# **H2Teesside Project**

The H2 Teesside Order

Document Reference: 8.2 Errata Report

Date: August 2024

Plate 9B-9: Salinity Data for Tees Bay

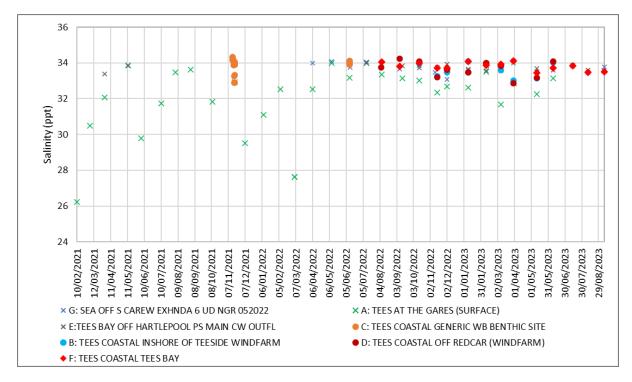
ERRATA LIST NO.	DOCUMENT TITLE AND REFERENCE NUMBER	PARAGRAPH NUMBER	PAGE NUMBER	NATURE OF AMENDMENT/ REASON FOR CHANGE	CORRECTION
	Modelling Report [APP-193]				survey of the W3 outfall which confirmed it could no longer be used II
					This work followed confirmation that a new offshore discharge location would be required because survey of an existing outfall (the W3 outfall) confirmed it could no longer be used
183	ES <b>Appendix 9B</b> Water Quality Modelling Report [APP-193]	Paragraph 9B.3.1	19	Incorrect cross reference	and is provided in Annex C and is provided in Annex B
184	ES <b>Appendix 9B</b> Water Quality Modelling Report	Paragraph 9B.3.9	23	Incorrect cross reference	The wind speed data for the Delft3D model is described in Section A.3.5 in Annex C.
	[APP-193]				The wind speed data for the Delft3D model is described in Section A.3.5 in Annex B.
185	ES <b>Appendix 9B</b> Water Quality Modelling Report [APP-193]	Plate 9B-9: Salinity Data for Tees Bay	25	Amending legend	See Appendix D of this document.
